**ADDENDUM 2
TO THE CONTRACT PROVISIONS AND CONTRACT PLANS**

**NORTHSHORE UTILITY DISTRICT
CONTRACT NO. C0928 451
CONTROL VALVE FACILITY AND CONTROL VALVE VAULT**

G&O #18591.00

ISSUED THIS DATE: WEDNESDAY, SEPTEMBER 18, 2024

CIVIL
SHEET: C2-2
16 OF 56

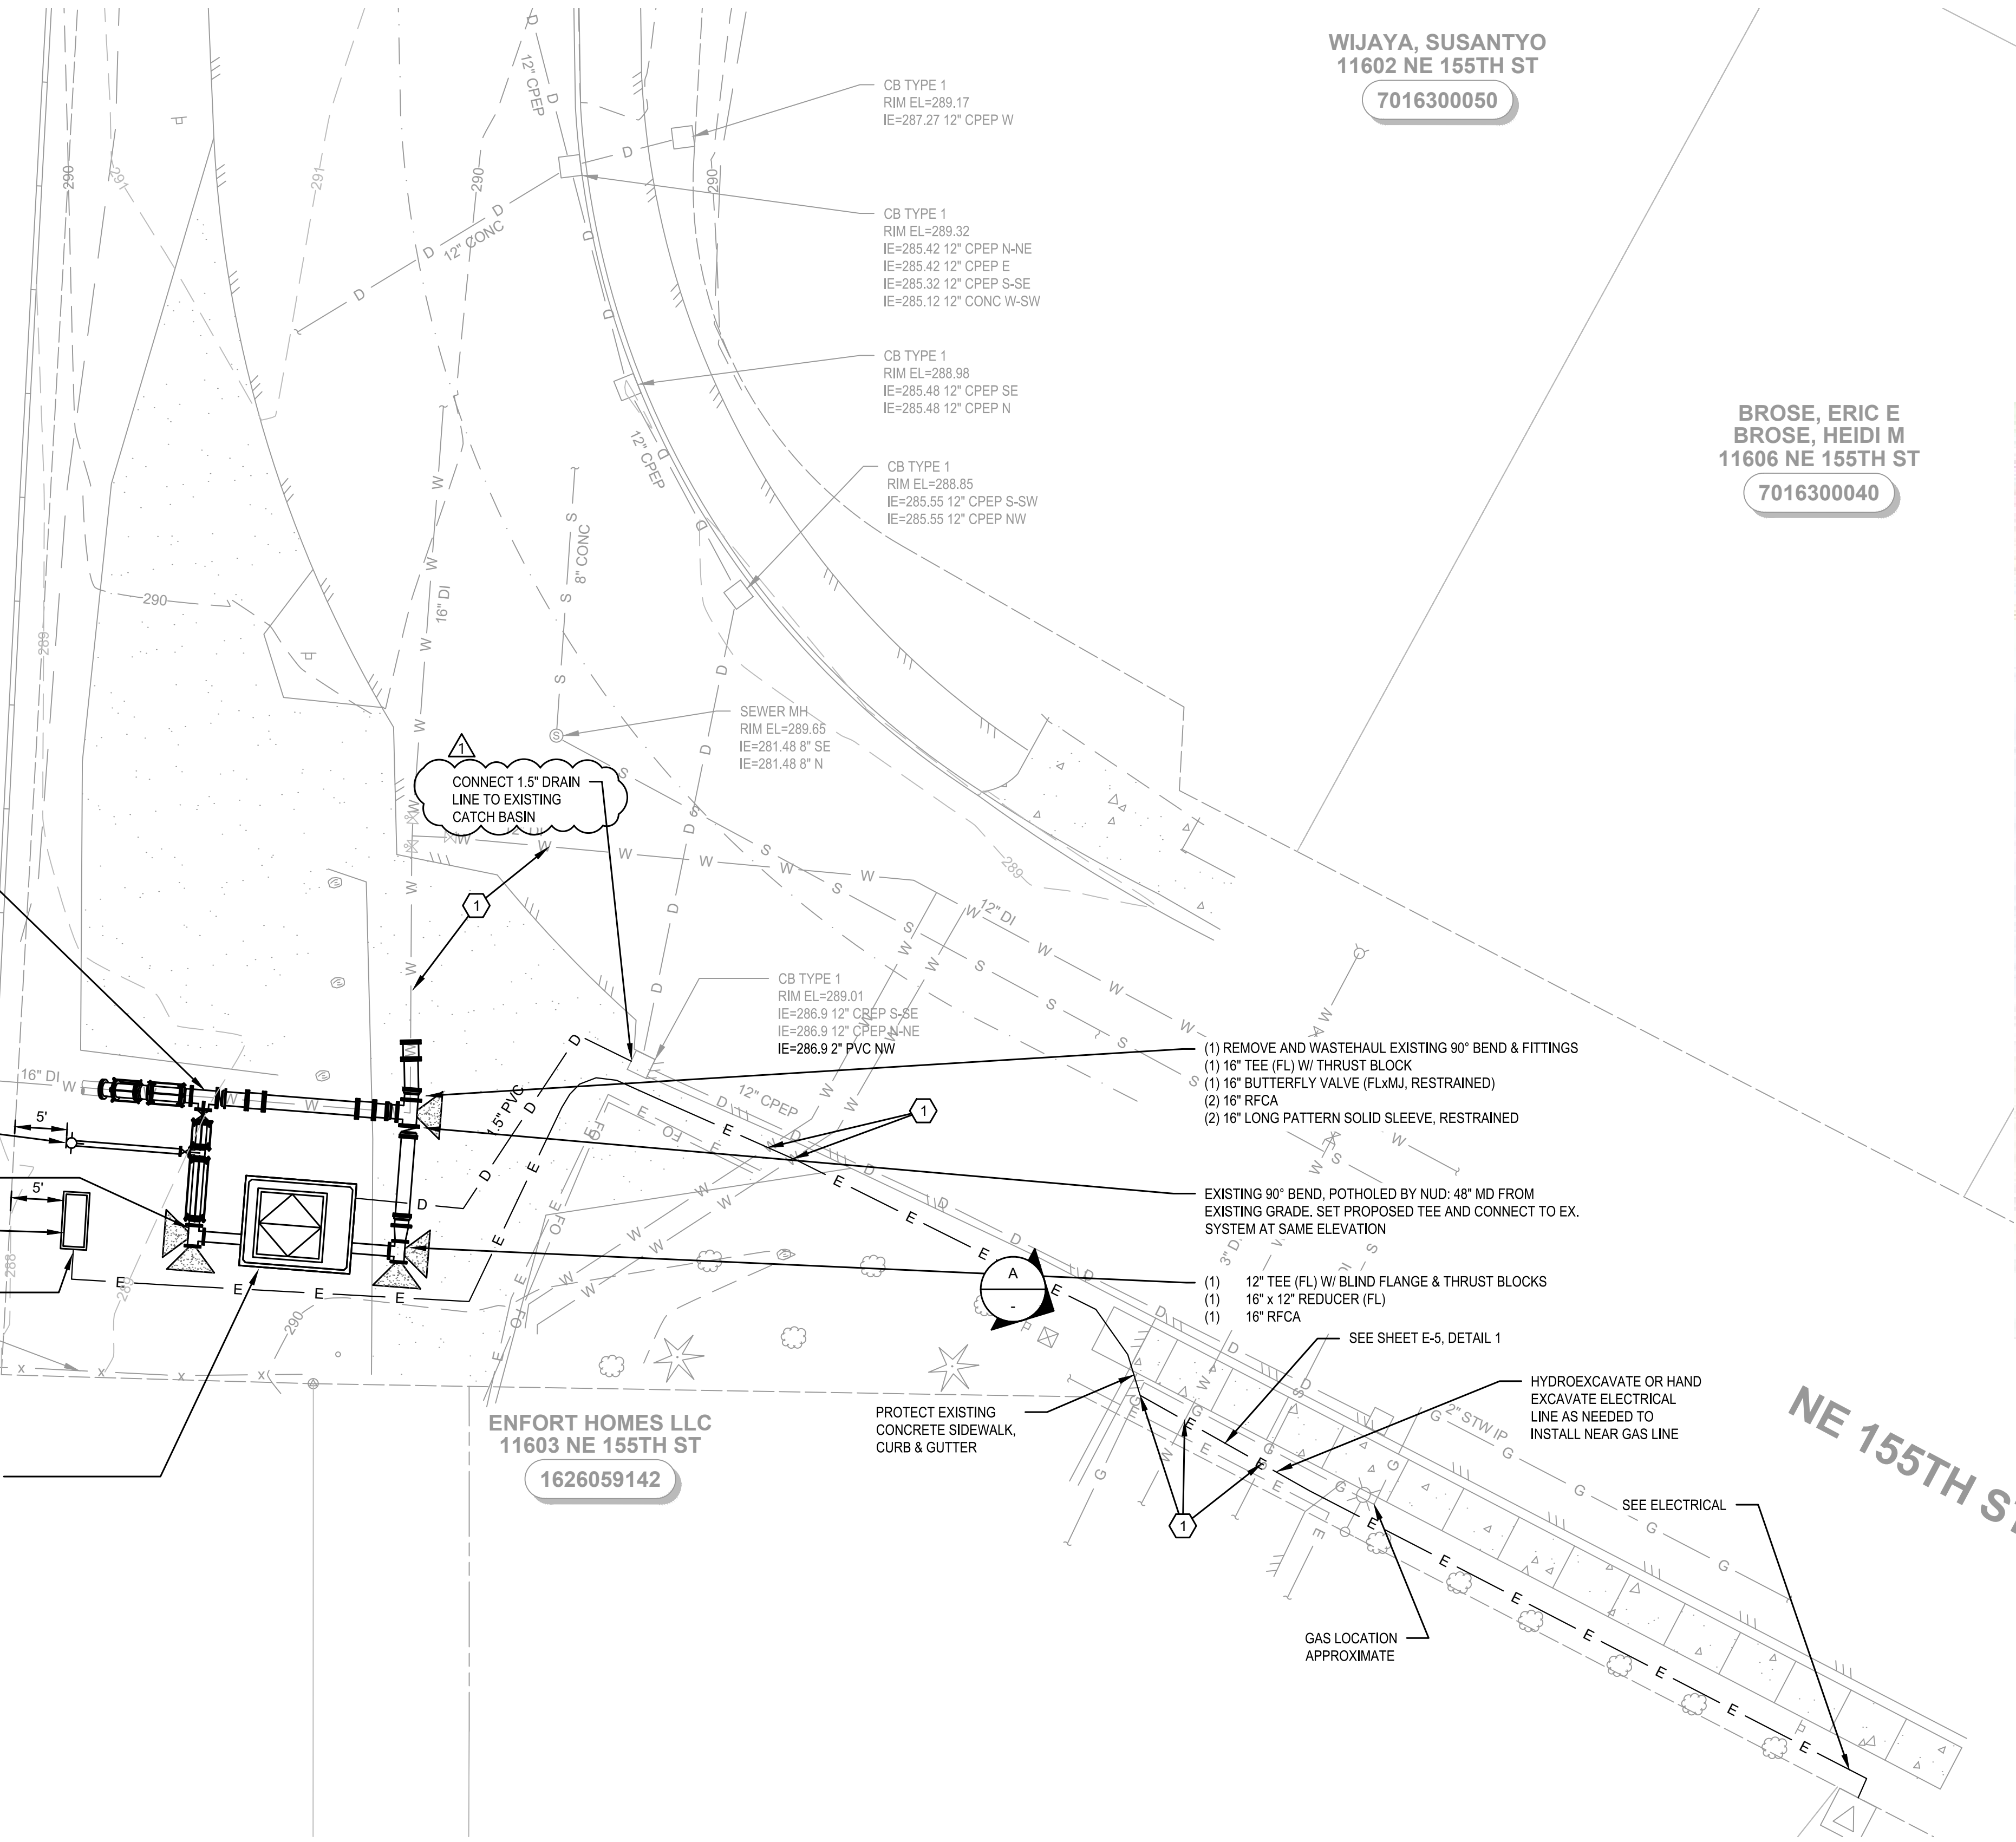
SHEET C2-2, SCHEDULE B PROPOSED PIPING PLAN

DELETE the callout “Connect to existing Sewer Manhole.”

SECTION C
SCALE: 3/4"=1'-0"

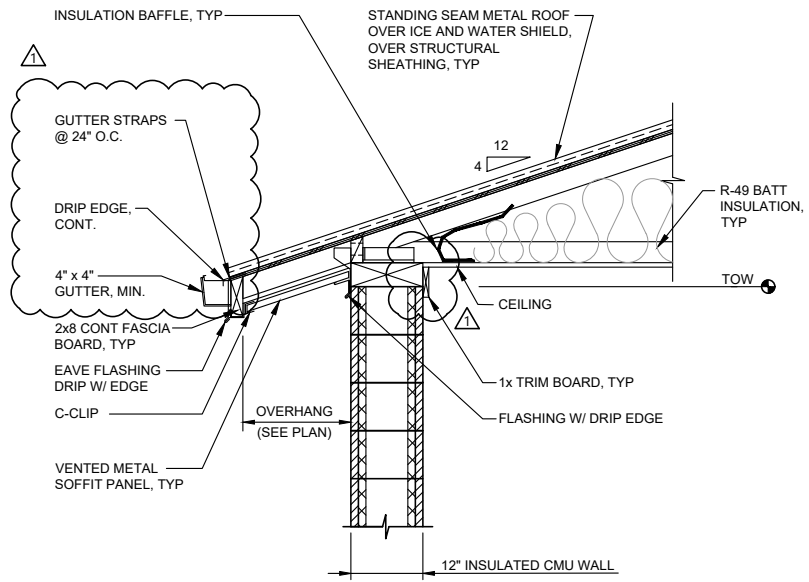
SHEET A1-4, SCHEDULE A BUILDING SECTIONS AND DETAILS

REPLACE Section “C” with the attached detail.

CLARIFICATION ROOF DETAIL
SECTION C
REFERENCE SHEET A1-4
